**ADDENDUM NO. 2
TO THE CONTRACT DOCUMENTS FOR
Well Number 8 Pump Building**

**WELL NUMBER 8 PUMP BUILDING
(RON WOOD PARK WELL)**

PROJECT NUMBER CW 20-02

SHEET
C-1A

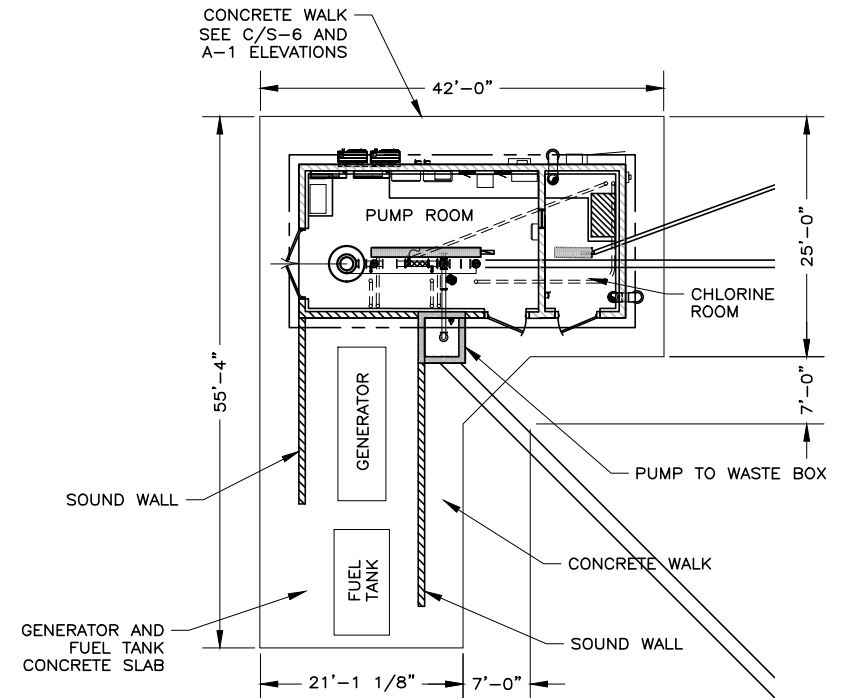
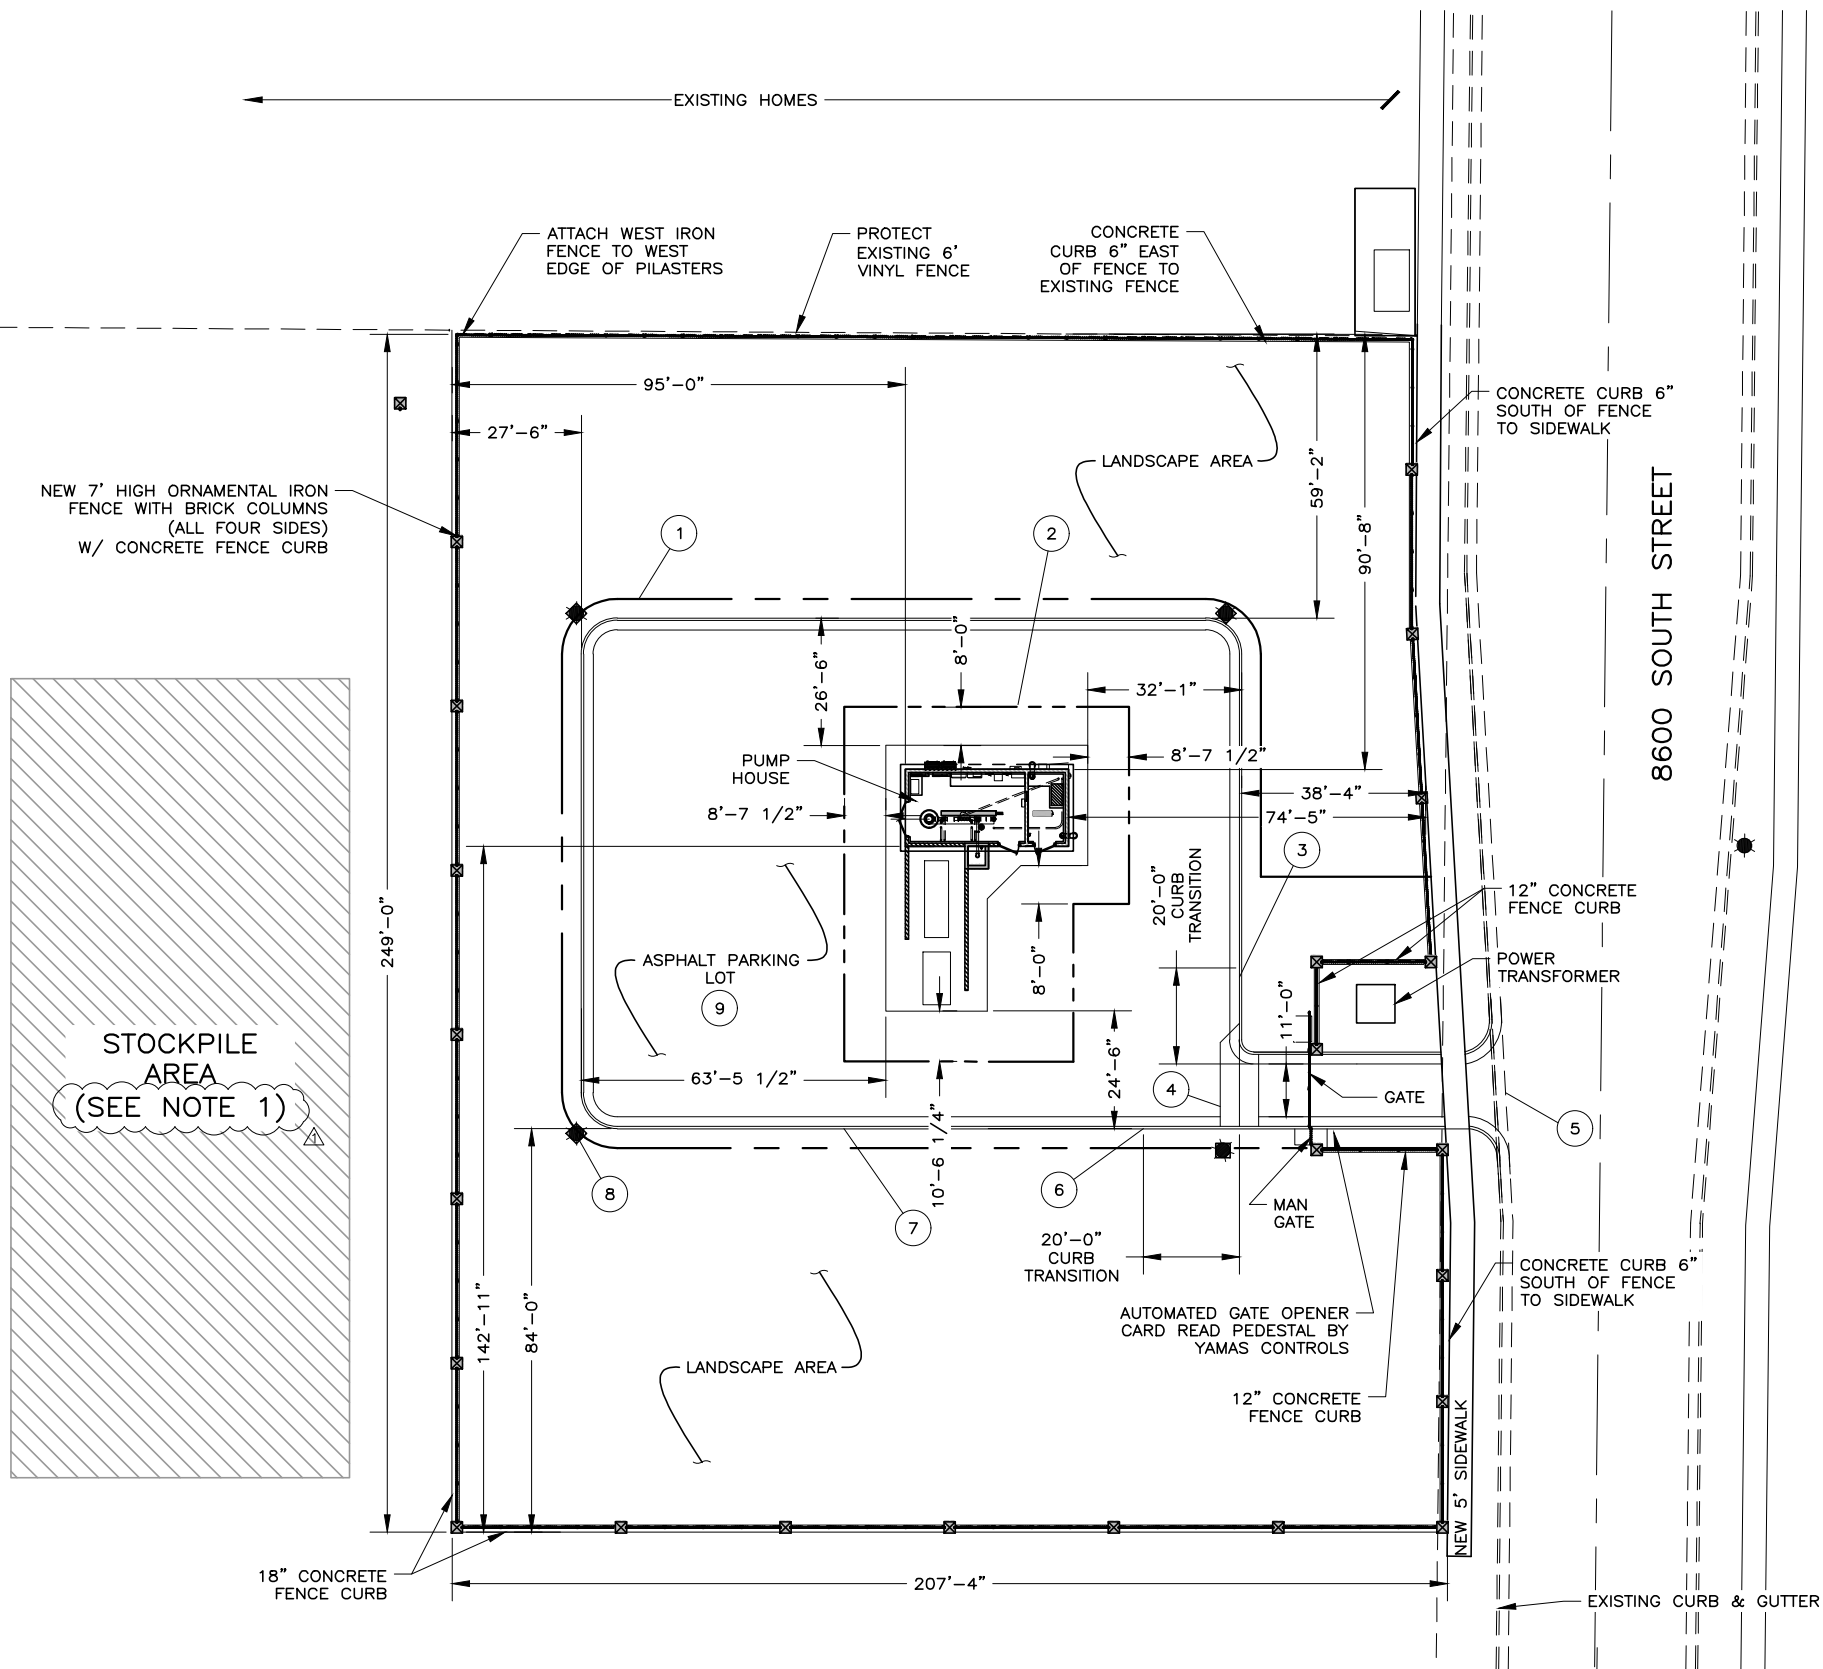
5. Section 31 23 23 Excavation and Backfill For Structures: Replace paragraph 3.2 with:
- A. Limits of shallow site over-excavation and fill requirements extend to 4 feet beyond curb line, as indicated on Sheet C-1A Note 1 in Contract Drawings.
